Palo Verde Nuclear
Generating Station

**Subject: Palo Verde Nuclear Generating Station (PVNGS) Unit 2
Docket No. STN 50-529
Unit 2 Core Operating Limits Report (COLR), Revision 17**

**PVNGS Unit 2 Core Operating Limits Report (COLR)
Revision 17**

Revision 17

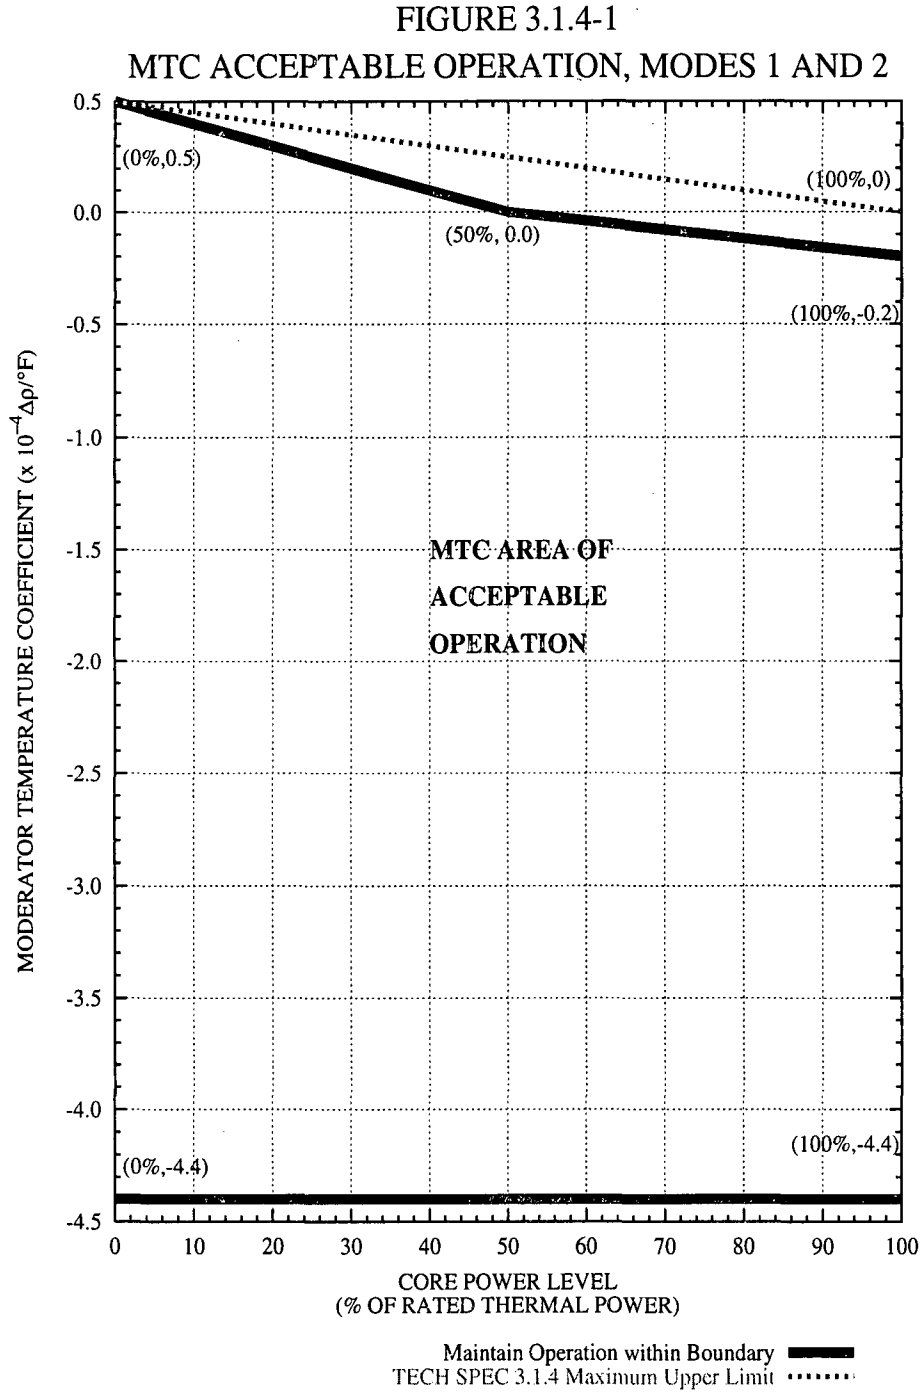
- Changed the format of the analytical methods table (pages 6 and 7 of 26)
- Enhanced the internal document numbers shown in the titles of several methods (pages 6 and 7 of 26)
- Added a revision number to Report No. CENPD-132 (page 6 of 26)
- Updated the date and revision number for Report No. NFM-005 (page 6 of 26)
- Added a Revision Number for Report No. CEN-160(S)-P (page 7 of 26)
- Revised Figure 3.1.4-1 to change the negative moderator temperature coefficient (MTC) lower limit (page 13 of 26)

The moderator temperature coefficient (MTC) shall be within the area of Acceptable Operation shown in Figure 3.1.4-1.
